Applicant has appeared before the HPC on five occasions, to address changes to original submission and to nail down materials to be used in the construction of this house.

Since that time the applicants have decided to stick to their original design. They are seeking reversal of the HPC decision.

The HPC made the following decisions.

2. Garage Door

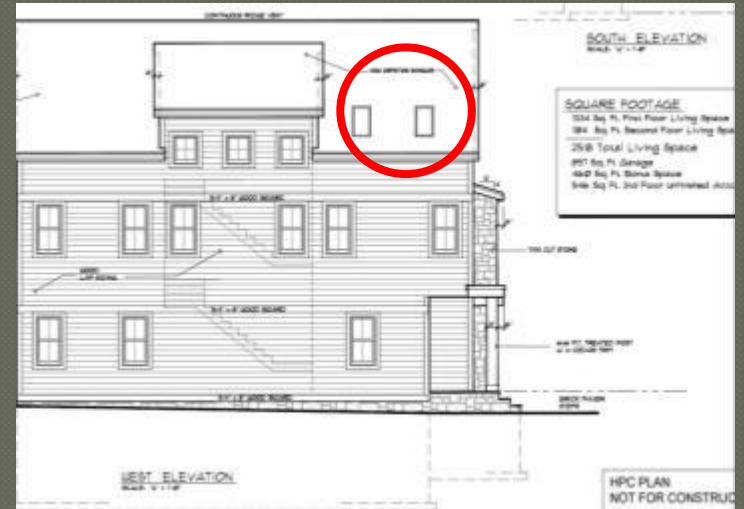
Applicant will install a garage door similar to this one.

HPC Approved

4. Use of Smartside as cladding material.

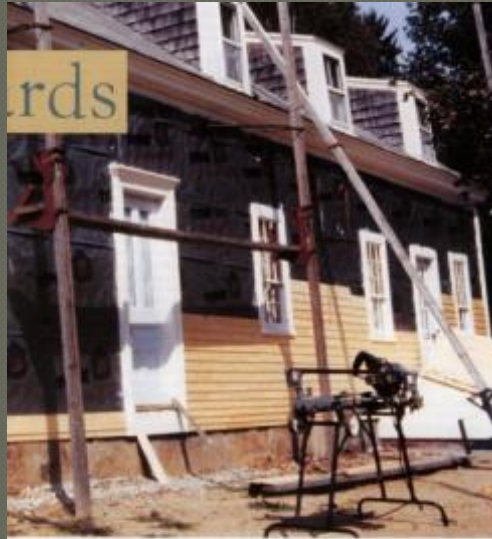
Smartside is a manufactured product made up of chipped wood, resins, etc. that is formed into boards. Early product had high failure rate but the product was reformulated. Has not yet stood the test of time. Not considered to resemble wood by preservation professionals.
